INSPECTION REPORT
Sedimentation Structure
J16-E
Kayenta Mine
Navajo County, Arizona
for
PEABODY COAL COMPANY

Dames & Moore
10139-011-22

CHANNEL PROFILE B-B'
J16-E

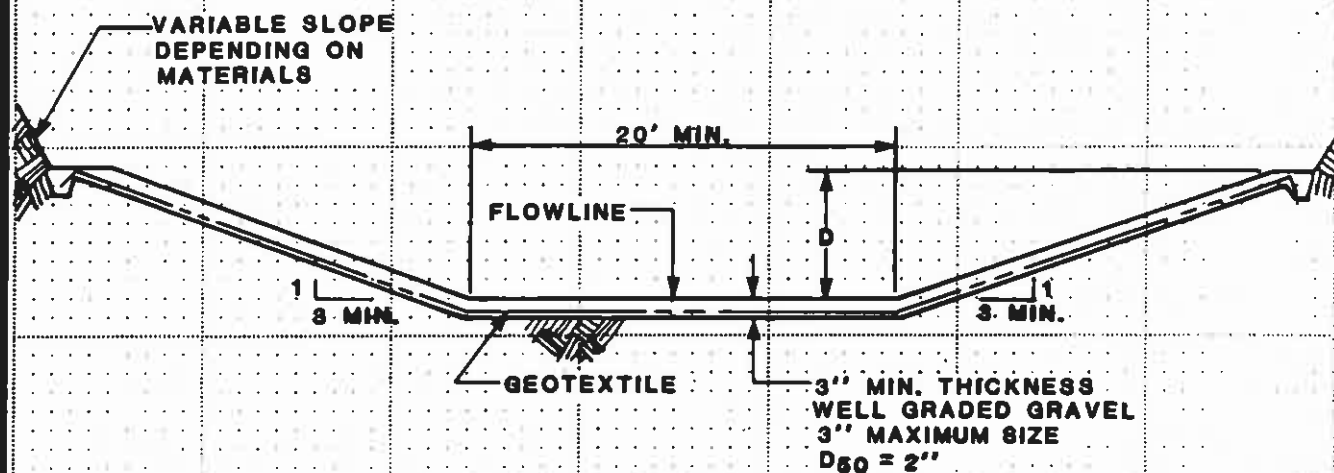
The storage capacity and spillway capacity of Structure J16-E are adequate. The outflow channel is protected with riprap but the spillway channel is not. The spillway channel should be protected against erosion using geotextile and gravel as shown in Plate 5. Plate 4 shows the existing spillway and outflow channel profile and Plate 5 shows the channel dimensions.
